**TOWN OF ERIE  
PLANNING COMMISSION MEETING  
August 7, 2019**

**SUBJECT:**           **Agenda # 19-322**

Review of Colliers Hill Filing No. 4G Sketch Plan

**PURPOSE:**       Review and comment on a Sketch Plan application for 201 single-family detached units.

Below is the Sketch Plan for the Colliers Hill Filing No. 4G site:

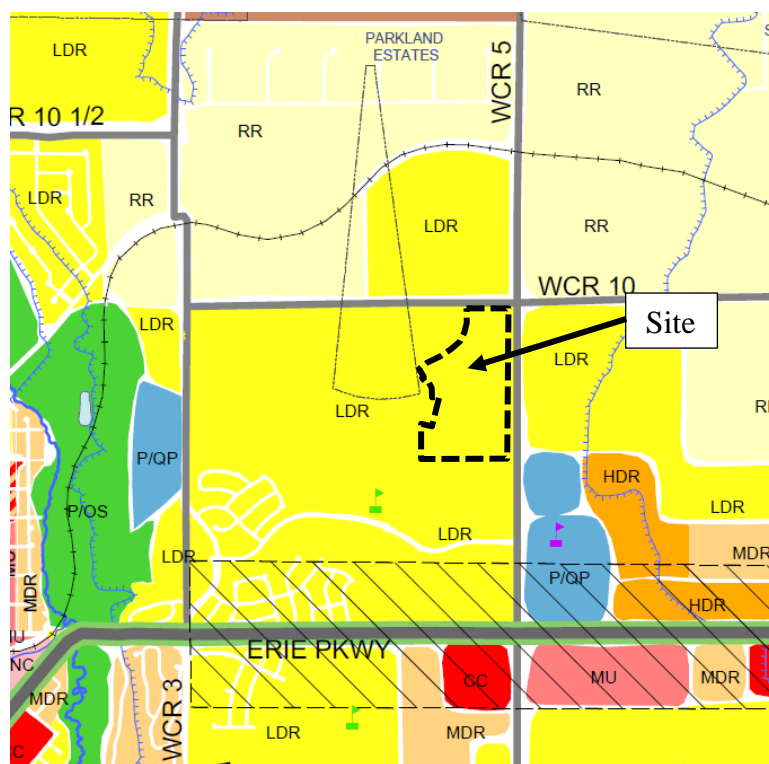
Access into the site is proposed from two points onto Flora View Drive on the south and Audubon Peak Drive on the North. The applicant's proposed Sketch Plan includes public roads within the development area. Staff would require the roads within the area to incorporate detached sidewalks and tree lawns to meet Town design standards.

County Line Road 5 to the east of the proposal is considered to be a community gateway by the UDC. As a gateway, additional design standards shall apply. These standards include a 30 foot landscape buffer, an eight foot sidewalk, screening of parking, and limits on fencing and signage.

A Pocket park is required per the UDC and PUD and is depicted on the Sketch Plan. Pocket parks shall comply with all Town Standards and Specifications. All parks and amenity areas will be accessible to the residents via trail linkages and block crossings. Pedestrian areas will tie into the larger open space and trails network with the overall Colliers Hill Development.

The Parks Department stated concerns with the lack of on street parking contiguous to the neighborhood park. Parks also requested the lots on the east of the park to be removed. Further discussions will be required prior to Preliminary Plat.

Future plan submittals should illustrate how parks and trails connections are being made to the existing and proposed trail and park infrastructure. The Parks Division has provided the applicant with comments.

Below are the proposed changes to the PUD. The existing PUD is on the left and the proposed amendment is on the right.

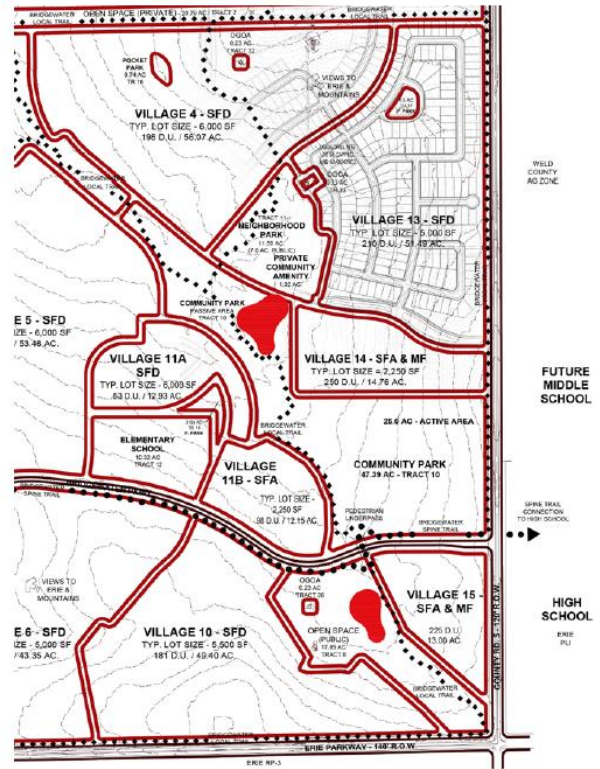
The proposed Sketch Plan is inconsistent with the existing PUD. Because of the applicant's proposed Sketch Plan, an amendment to the PUD to allow the project is required.

The Sketch plan proposes to change land uses by:

- Expanding standard Single-Family Detached lots of 5,000 square feet or more by 51.5 acres, which would allow up to 210 dwelling units. This expansion would combine Villages 13 and 14.
- Eliminating Village 13 consisting of 210 patio homes (3,500 to 5,000 square foot lots) on 41.29 acres.
- Eliminating Village 14 consisting of 33 acres with 260 units of townhomes and duplexes.
- Change Village 15 from 9.5 acres with 250 dwelling units of apartment only dwellings to 14.76 with 250 units of single-family attached (townhomes or multi-family apartments).
- Change Village 16 from 13 acres with 225 apartment only dwelling units to 13 acres with 225 single-family attached and/or multi-family.

The proposed amendment significantly reduces the land area dedicated to alternative housing types.
